**ADDENDUM #5**

**Will County Health Department**  
**BID PACKAGE #2 – Misc. Steel/Structural/Enclosure**  
**November 15, 2018**

**SECTION 00 91 07  
BP #2 - ADDENDUM NUMBER 5**

**PROJECT:**           **WILL COUNTY HEALTH DEPARTMENT - NEW HEALTH DEPARTMENT  
BUILDING  
501 ELLA AVENUE  
JOLIET, ILLINOIS 60433**

**A501**

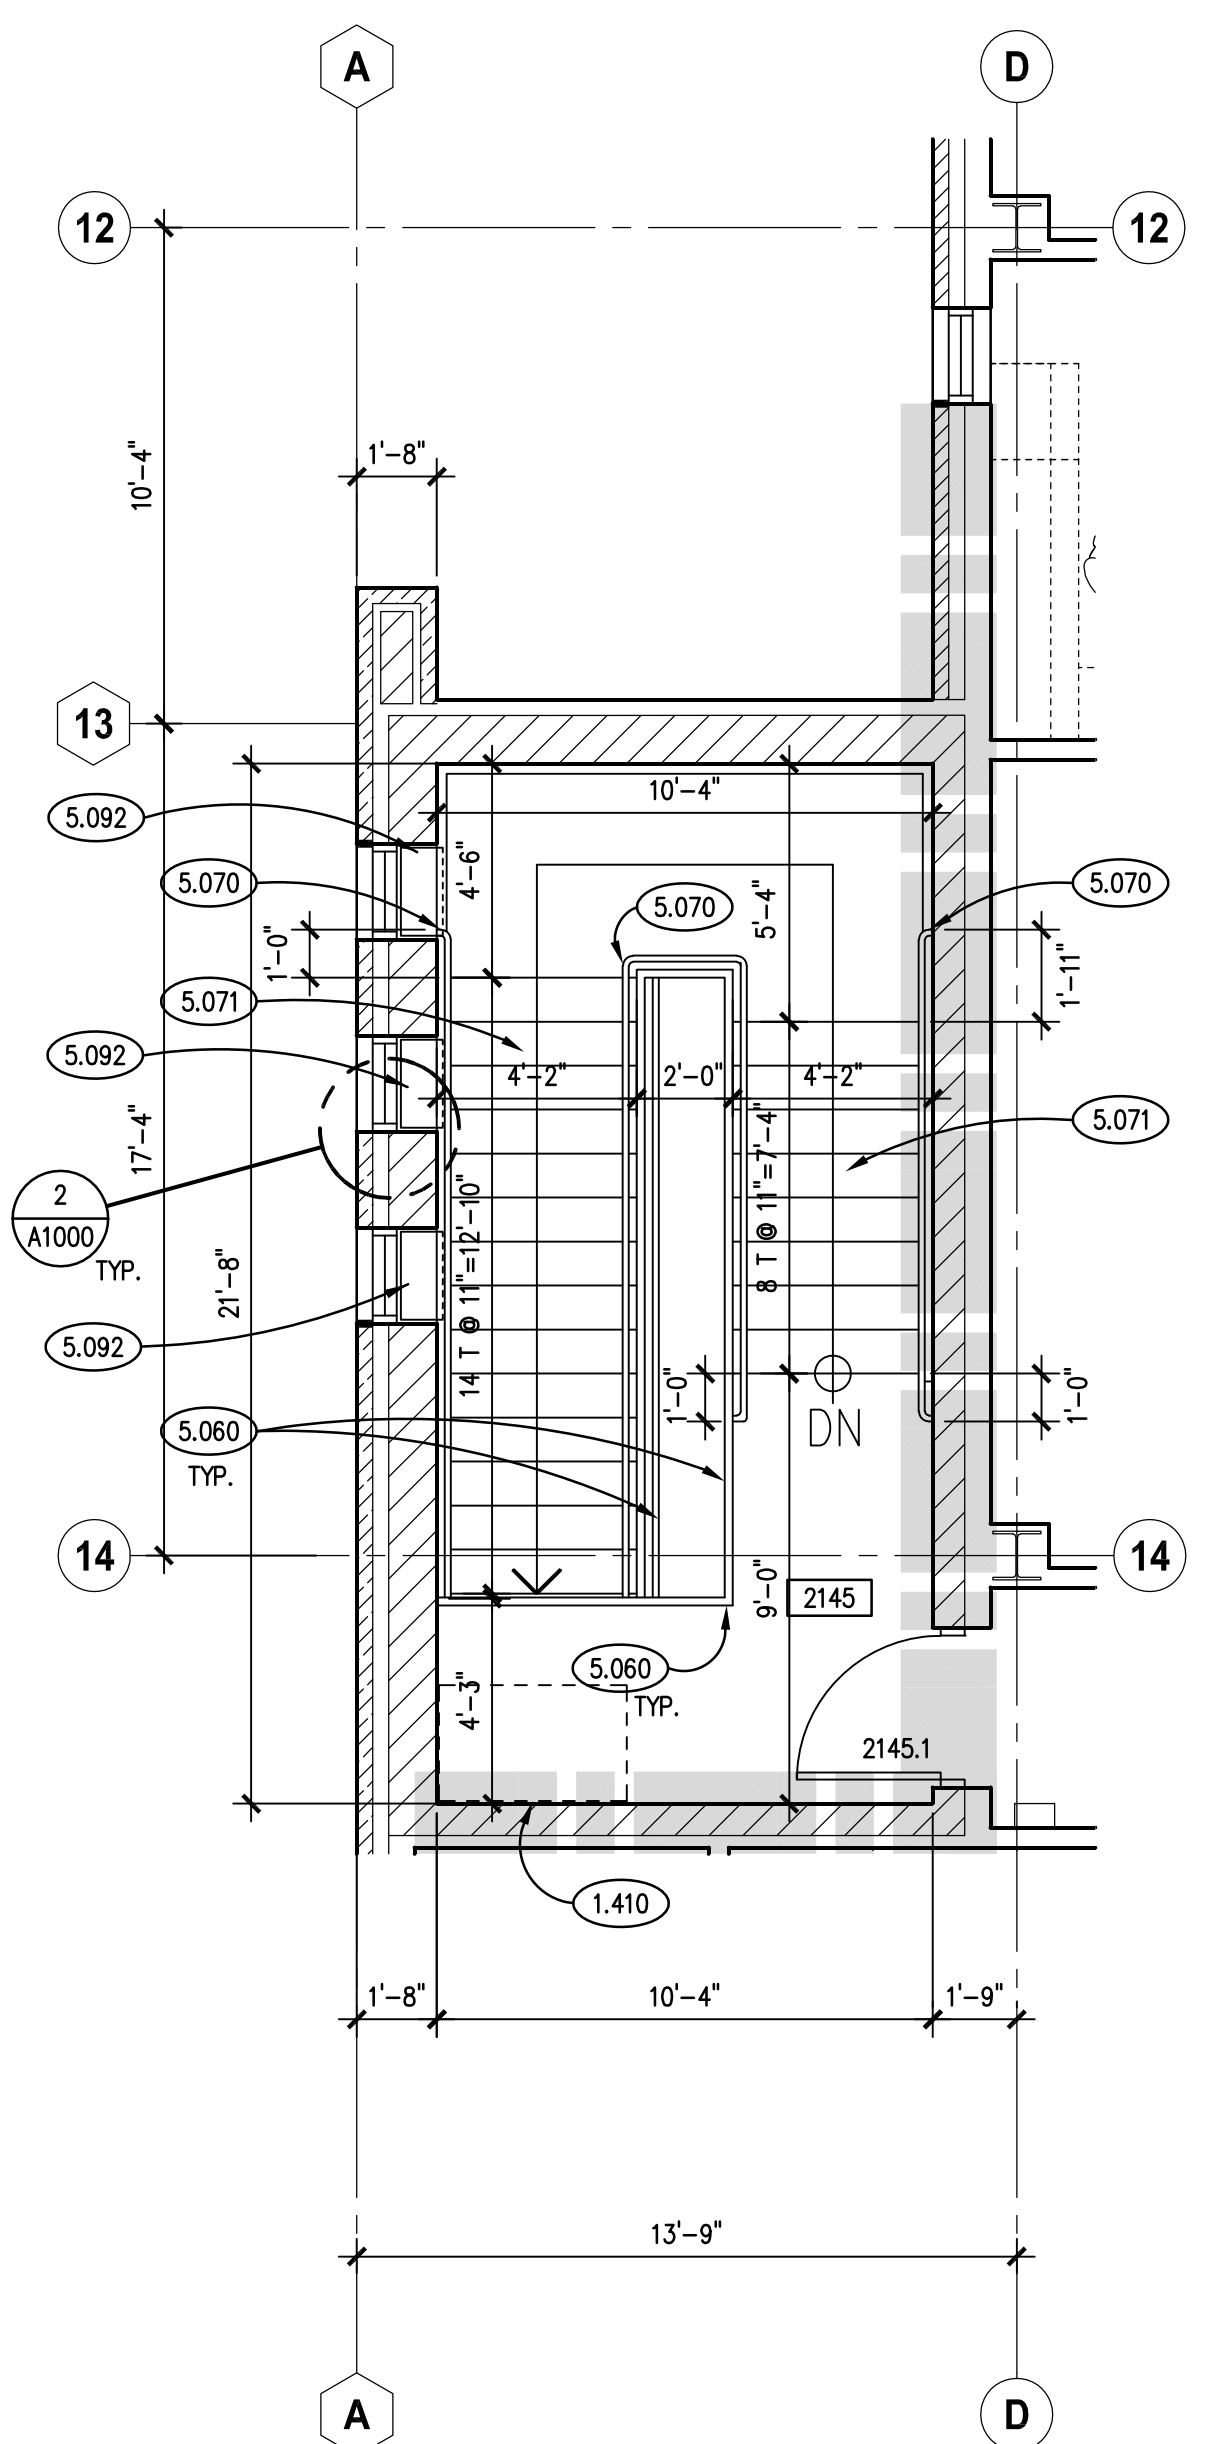
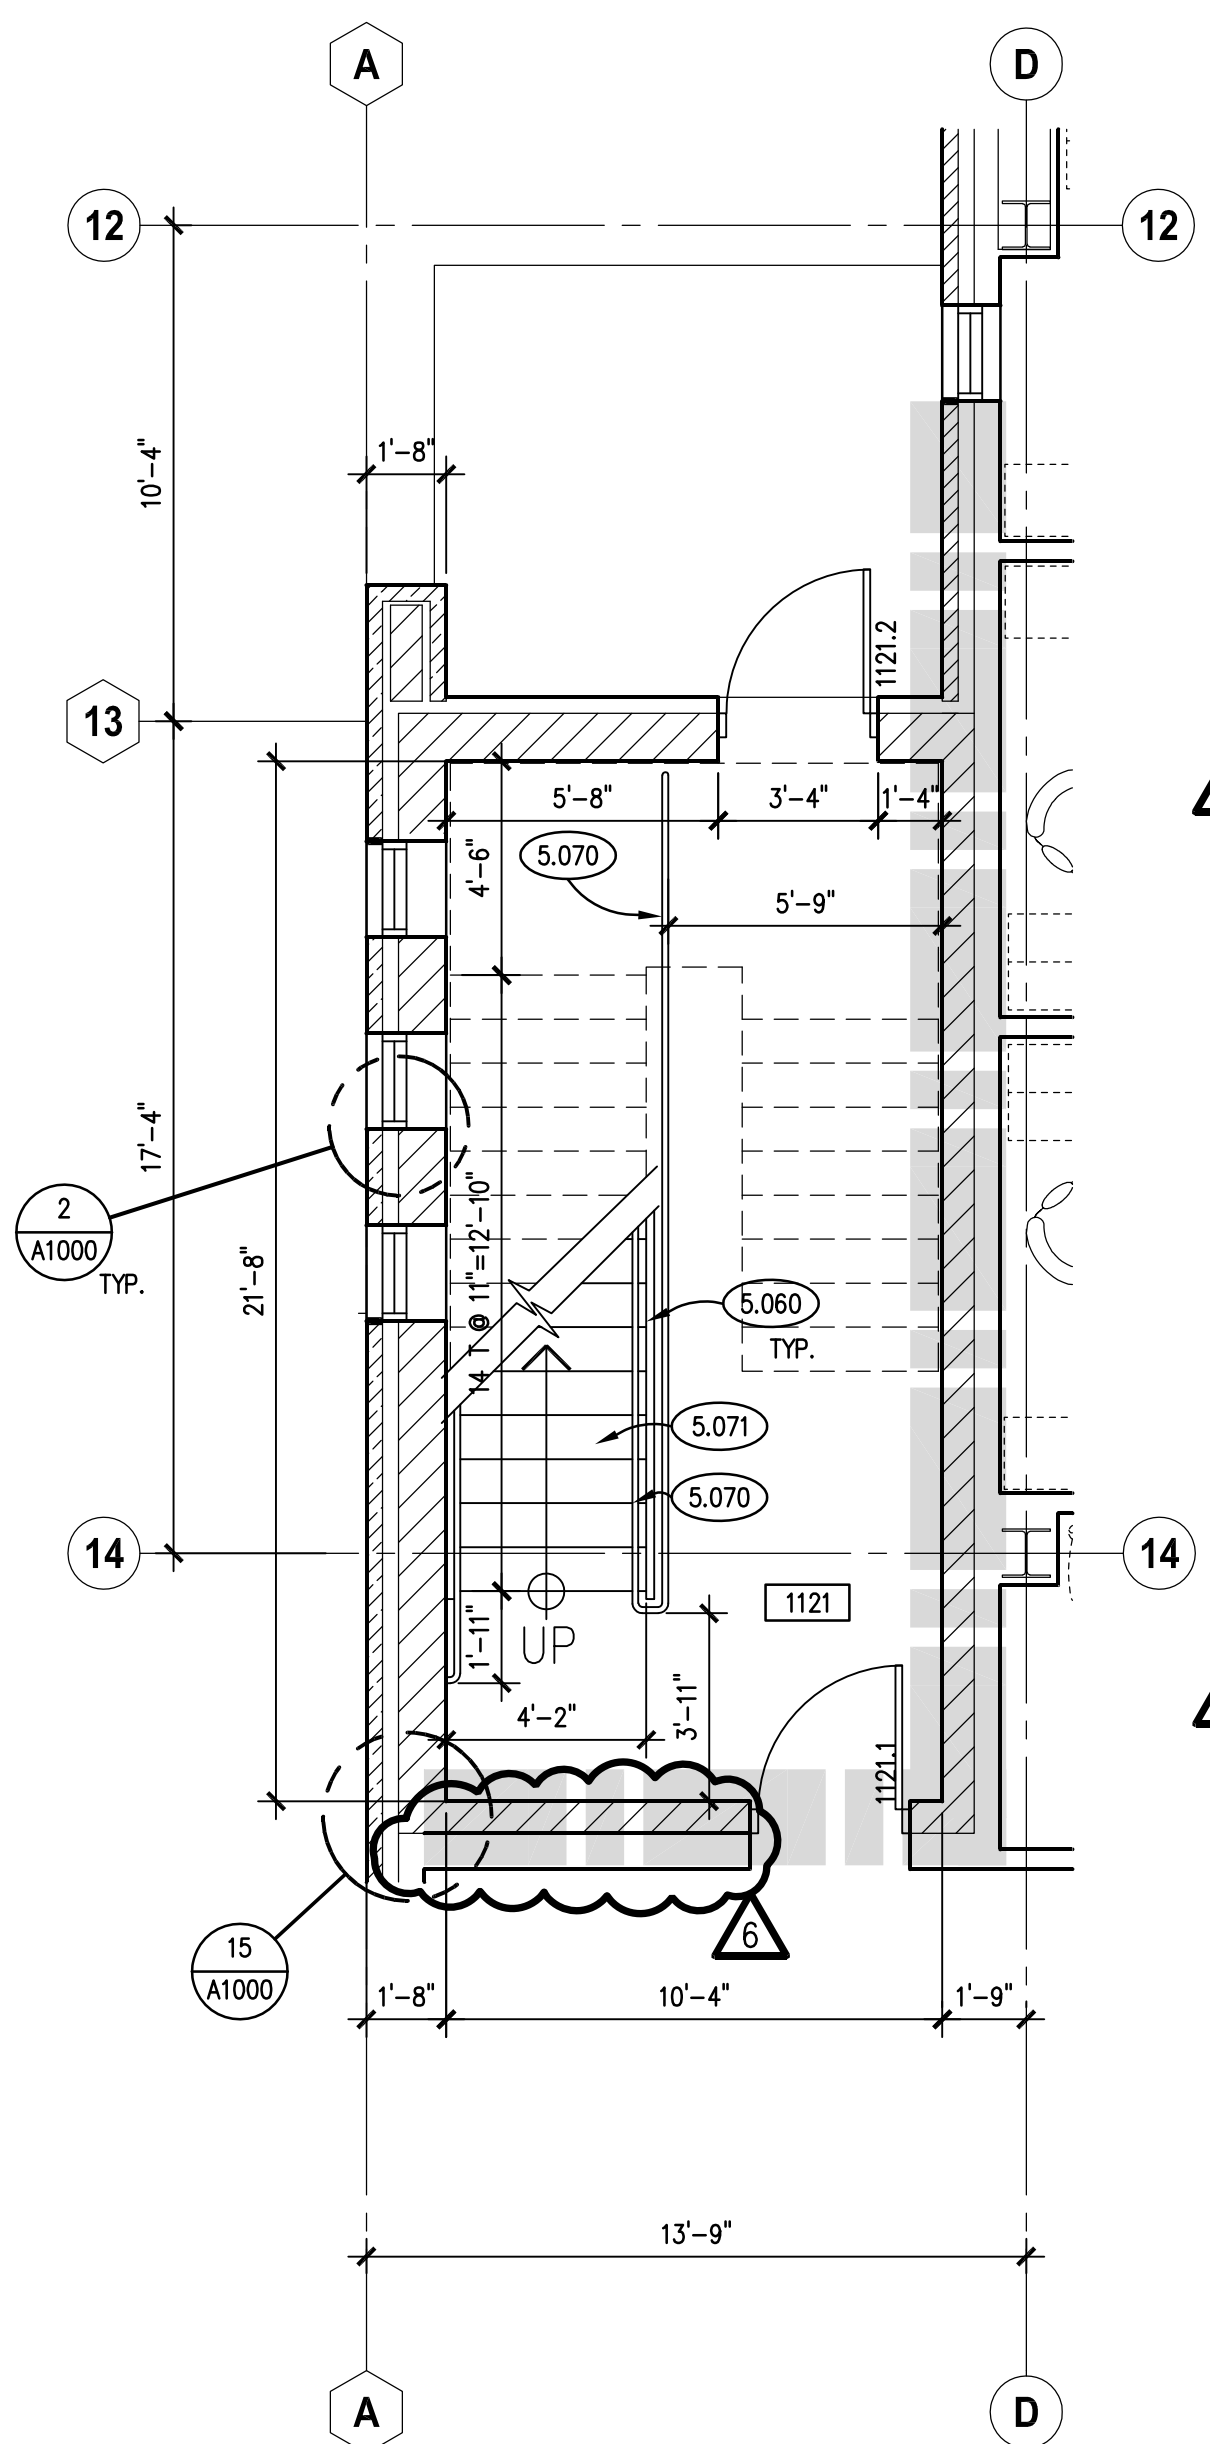
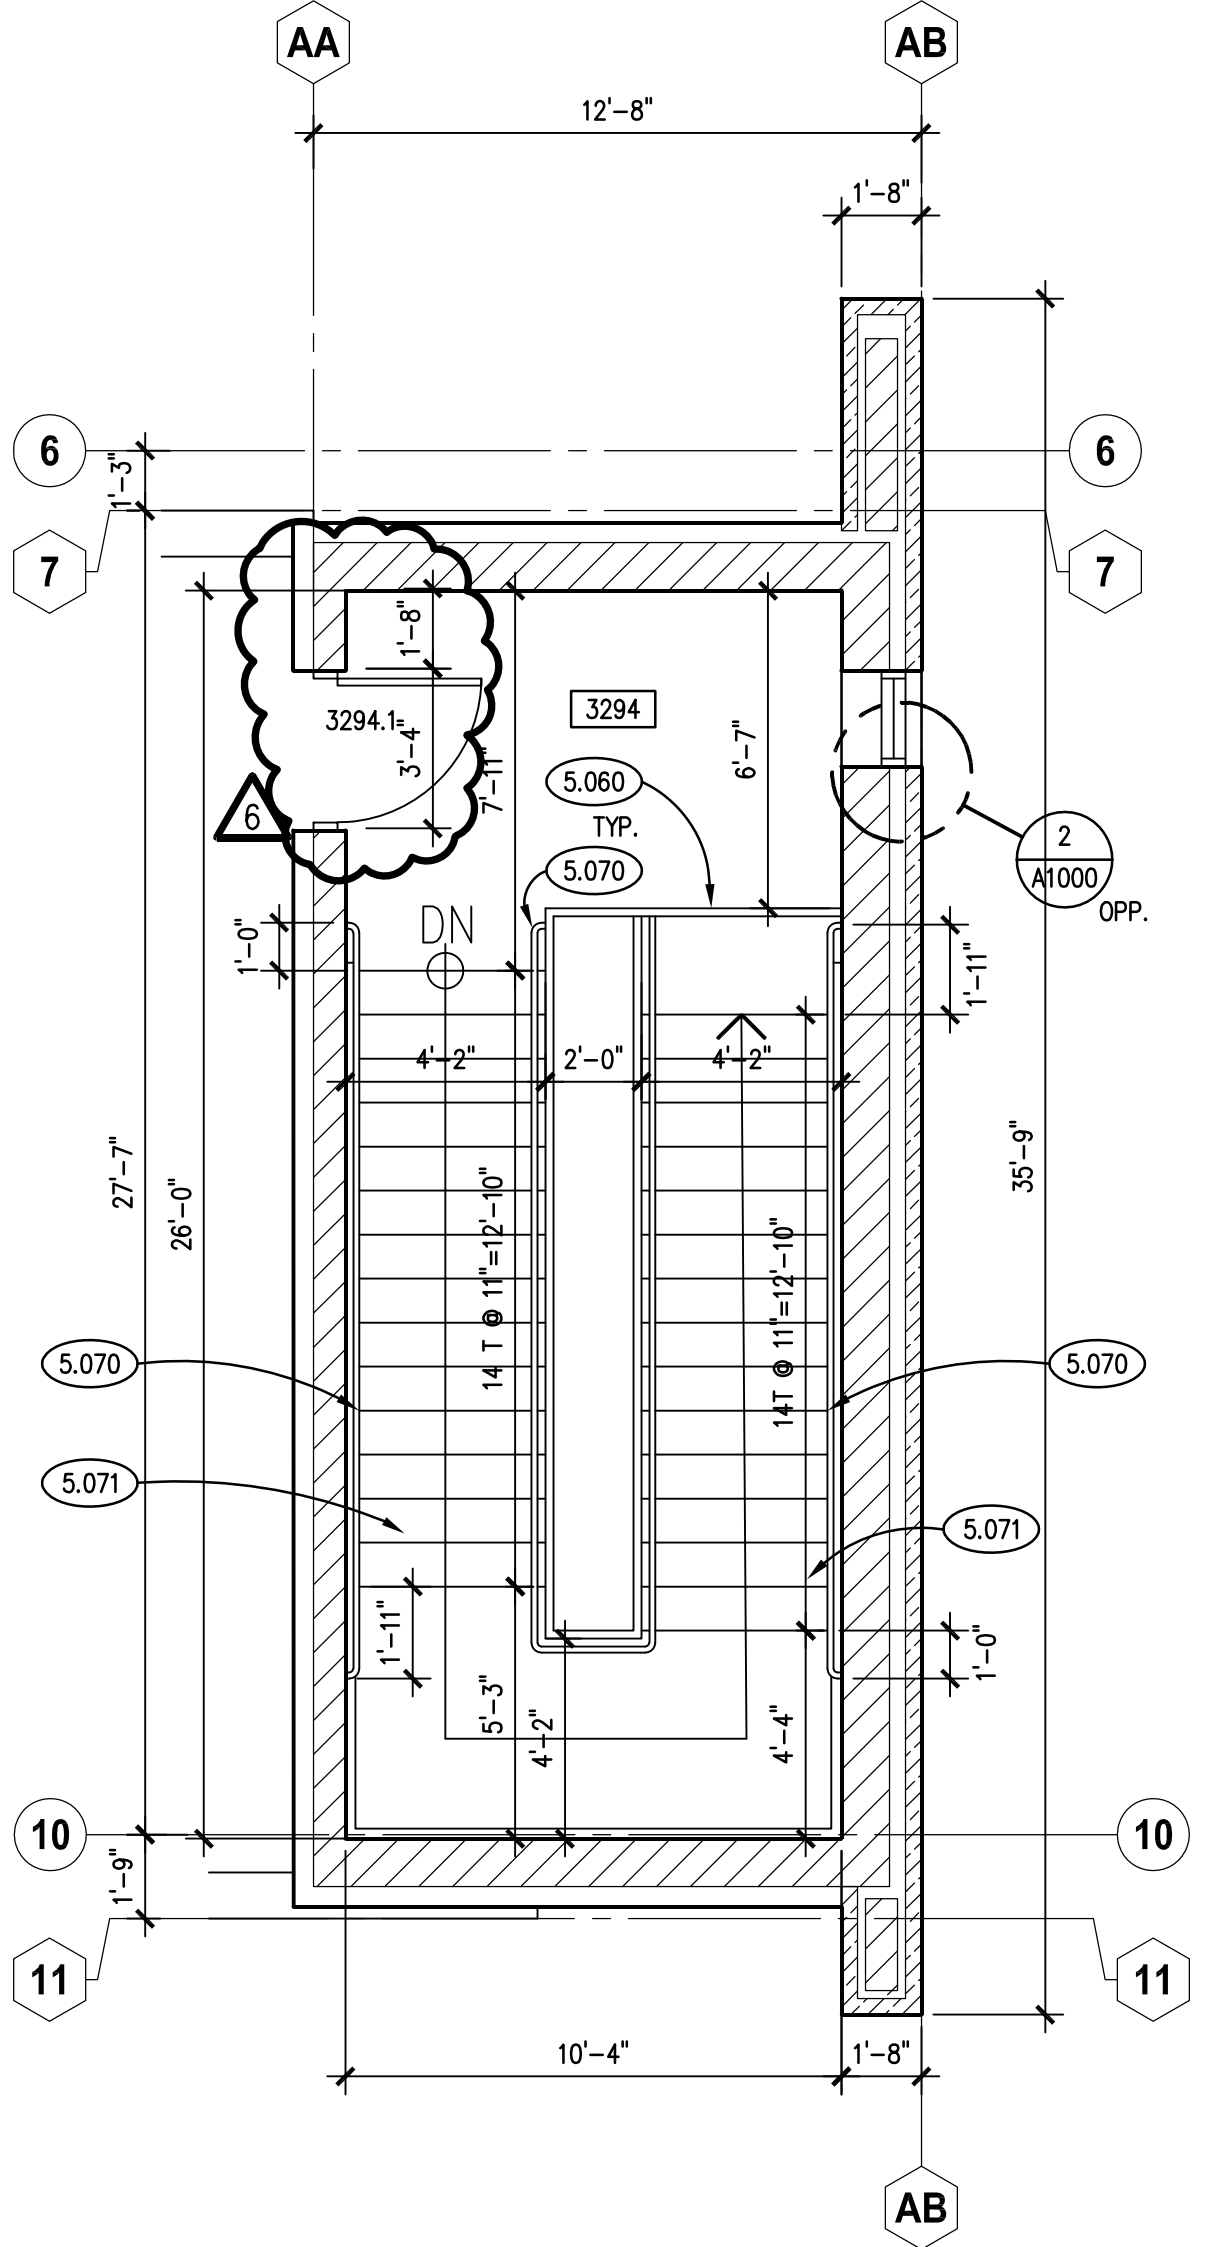
- A. Detail 8/A501: Added post location dimensions for the central handrail assembly at the ornamental staircase.
